PLANNING AND ZONING COMMISSION MEETING

CITY OF CREVE COEUR, MISSOURI

MONDAY, JUNE 18, 2018

APPLICATION TO PLANNING AND ZONING COMMISSION #18-024: A MINOR SITE DEVELOPMENT PLAN FOR A SIX-FOOT TALL TAN VINYL FENCE AND 4 FOOT ALUMINUM FENCE WITHIN THE FRONT-YARD SETBACK ALONG LITCHEFORD WAY AND LITCHEFORD COURT FOR THE PROPERTY AT 227 LITCHEFORD COURT

Figure 1: Close-up of Applicant's site plan, the pink dashed line shows that the wall will be on top of the retaining wall.

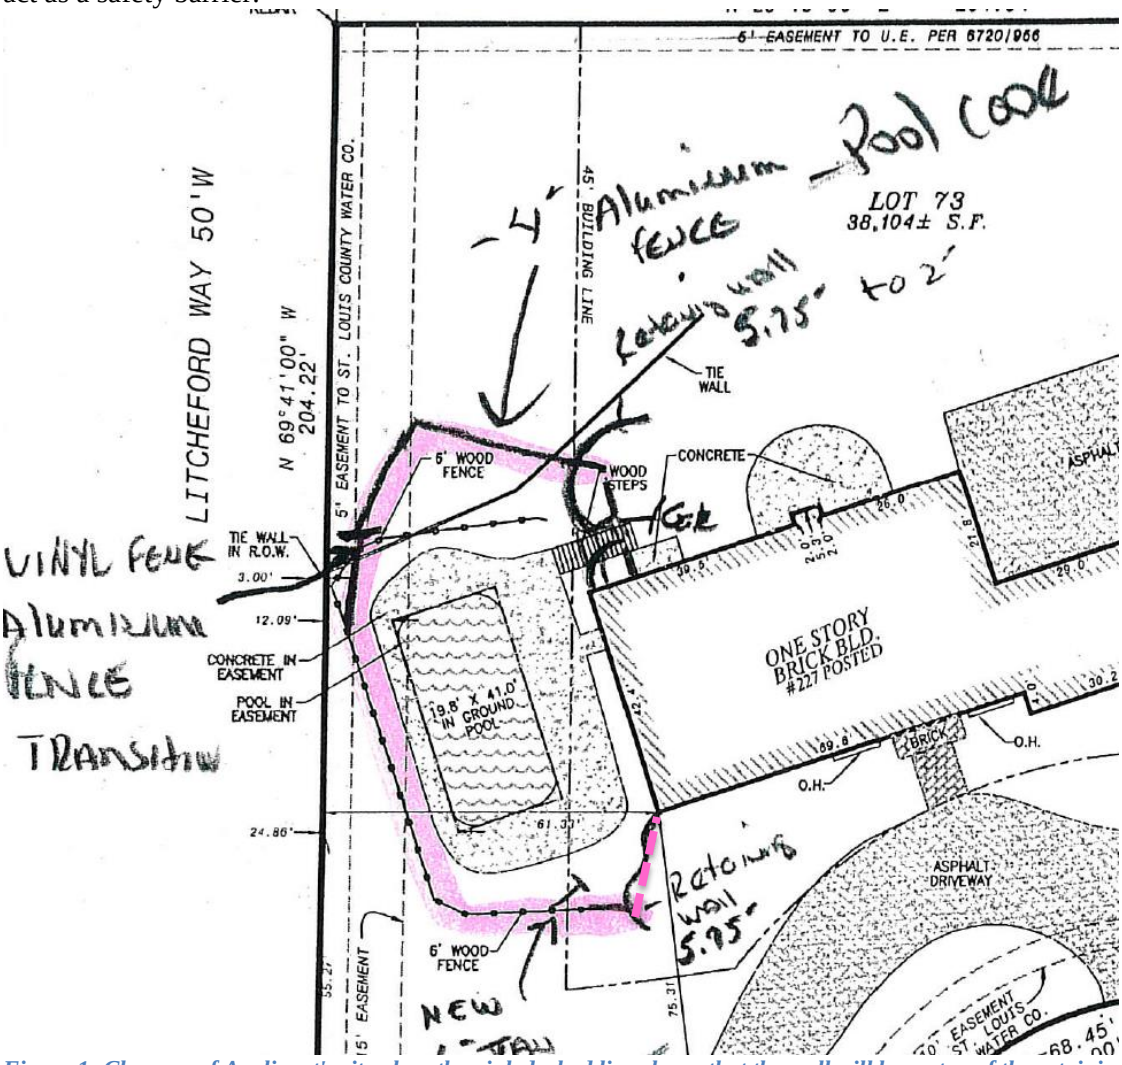
FENCE PLACEMENT AND DESIGN
The Applicant is seeking to replace the existing wood fence with a six foot tall, tan vinyl fence approximately five feet from the south property line within the setback of Litcheford Way that will wrap around eastward to the front and along the top of the retaining wall within the setback of Litcheford Court. A four-foot tall open picket fence will then enclose the western portion of the existing pool area to meet with building code requirements as a pool barrier. Not clearly indicated but part of the request is that the tan vinyl fence will follow along the top of the 5.75 foot retaining wall to connect to the home and act as a safety barrier.

Further, the Design Guidelines recommend the use of natural "green" materials, and discourages the use of synthetic, and highly reflective materials. The proposed fence material is a light tan color, vinyl fence material which is not consistent with the Design Guidelines. In a standard application within residential settings, the tan vinyl has been approved; however, this application is a highly visible area within the front setback of the public right-of-way that is subject to further review by the Planning and Zoning Commission. The building code requires a fence surrounding the pool, as well as on top of the 5.75 foot retaining wall for safety purposes. With these considerations, the request before the Commission is a review of the material and the height of six feet and that a portion will be on top of the retaining wall within the front yard setback.

- That the fence should be a consistent 4 foot tall open slatted metal fence all the way around, and that upright evergreens could be included to provide the privacy that the homeowner is seeking and to soften the appearance from the street consistent with the Design Guidelines and the Zoning Code.
- If the Commission finds that the reasons for the six foot fence are appropriate, Staff recommends that it should be a darker color to blend in with the landscaping and to match the main home, and that upright landscaping be required for the Zoning Administrator's approval to break up the appearance of the fence as viewed from the street.
- The portion of the fence acting as a safety barrier on the on top of the retaining wall shall be limited to four-feet in height, with an open slatted design and metal material to match the other section of fencing.

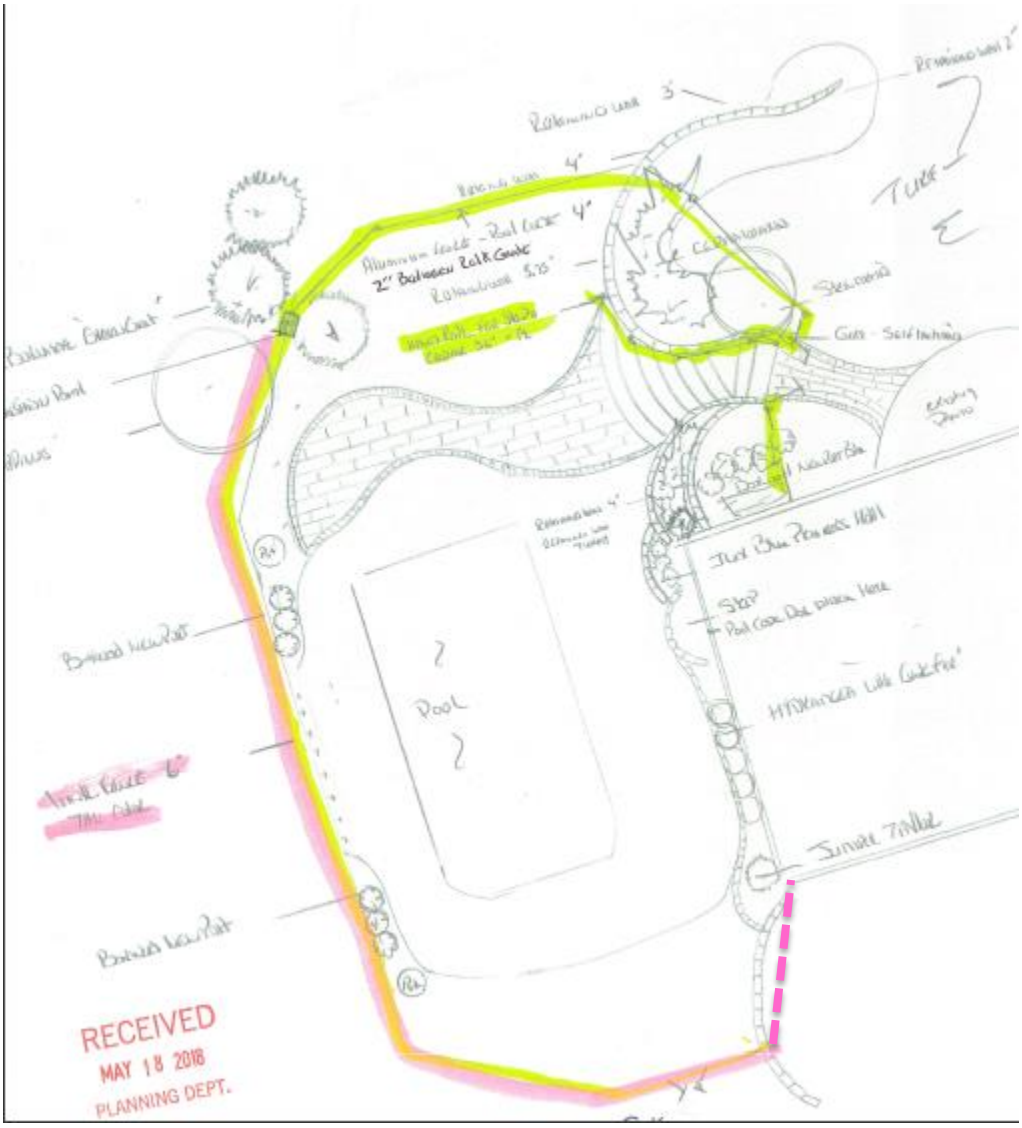
Figure 2: Landscape Plan indicting the 6 foot vinyl fence in pink and the 4 foot open slatted in yellow. Not indicated on the Applicant's drawing (but shown above in the pink dashed line) is that the tan vinyl fence will also connect to the home on top of the retaining wall and not end at the retaining wall.
